Project: Riverbend Park Renovation Phase One
Oroville, California

Date of Plans: January 30, 2018

General: This Addendum No. 2 shall be inserted into the Contract Documents for the referenced project and shall take precedence over the original Contract Documents.

CONCRETE STAIN – SMALL PICNIC SHELTERS

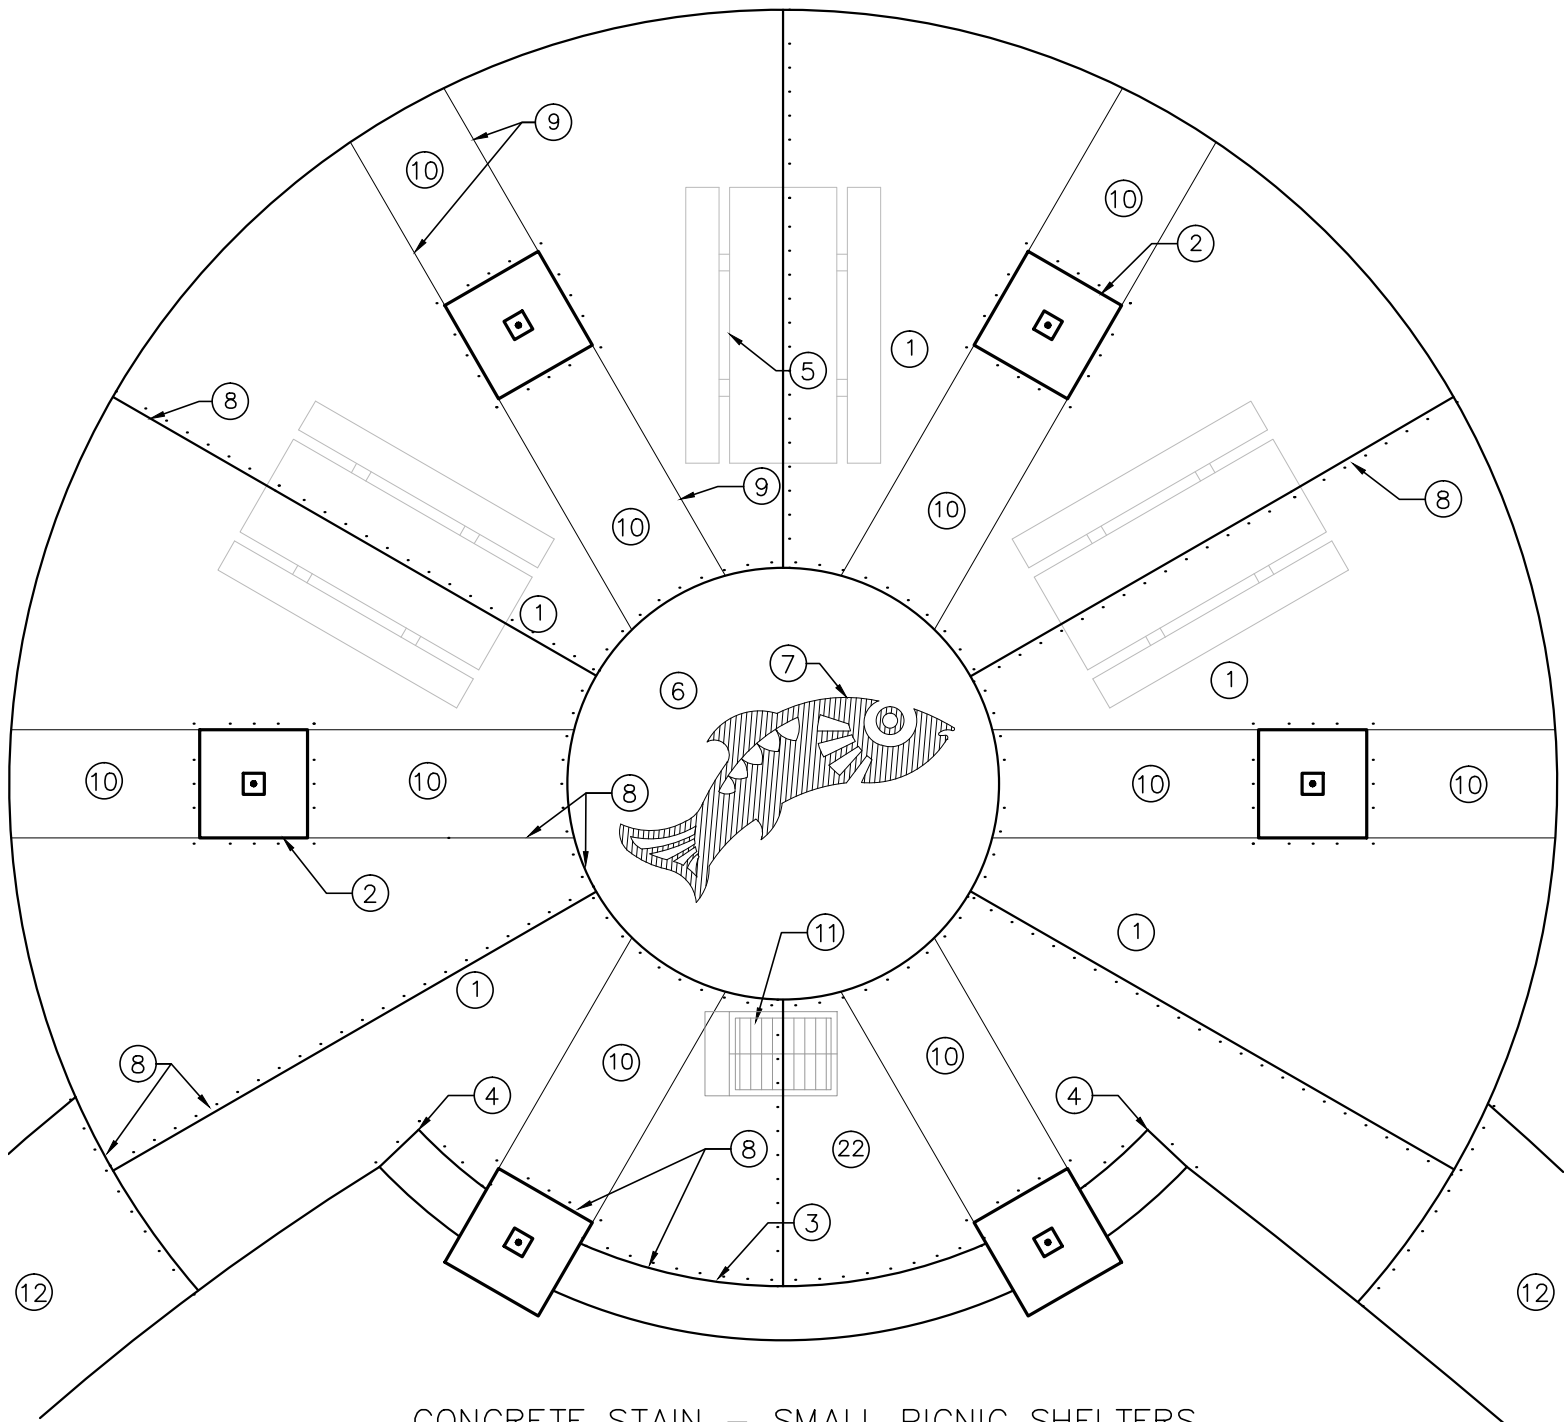
- d. Construction Legend, Item No. 46: DELETE Concrete ADA Picnic Table.
- e. Construction Legend, Item No. 49: Stain to be per attached detail "Concrete Stain – Small Picnic Shelters"

- ① CLEAN EXISTING CONCRETE SLAB
- ② EXISTING COLUMN
- ③ EXISTING 36" HIGH COBBLE VENEER SEATWALL
- ④ EXISTING 24" HIGH COBBLE VENEER SEATWALL
- ⑤ EXISTING CONCRETE PICNIC TABLE (TYP.)
MOVE AS NEEDED TO STAIN CONCRETE

- ⑥ CLEAN AND STAIN EXISTING CONCRETE WITH LITHOCHROME CHEMSTAIN - COLOR: CS-16 (FADED TERRACOTTA), SEAL WITH CEMENTONE CLEAR SEALER; BOTH AVAILABLE FROM L.M. SCOFIELD CO. (800) 800-9900

- ⑦ CLEAN EXISTING ANIMAL SANDBLAST PATTERN
TWO SHELTERS TOTAL - ONE FISH AND ONE BEAR
- ⑧ EXISTING EXPANSION JOINT (TYP.) 1/2" WIDE
CLEAN AND CAP WITH RESILIENT POLYURETHANE SEALANT. MATCH CONCRETE COLOR.

- ⑨ EXISTING SCORELINE (TYP.)
- ⑩ CLEAN AND STAIN EXISTING CONCRETE WITH LITHOCHROME CHEMSTAIN - COLOR: CS-14 (DARK WALNUT), SEAL WITH CEMENTONE CLEAR SEALER; BOTH AVAILABLE FROM L.M. SCOFIELD CO. (800) 800-9900

- ⑪ NEW CHARCOAL GRILL PER PLAN.
GRIND DOWN ANY EXPOSED METAL FROM OLD GRILL
INSTALL NEW GRILL OVER OLD GRILL LOCATION
- ⑫ EXISTING CONCRETE PATH
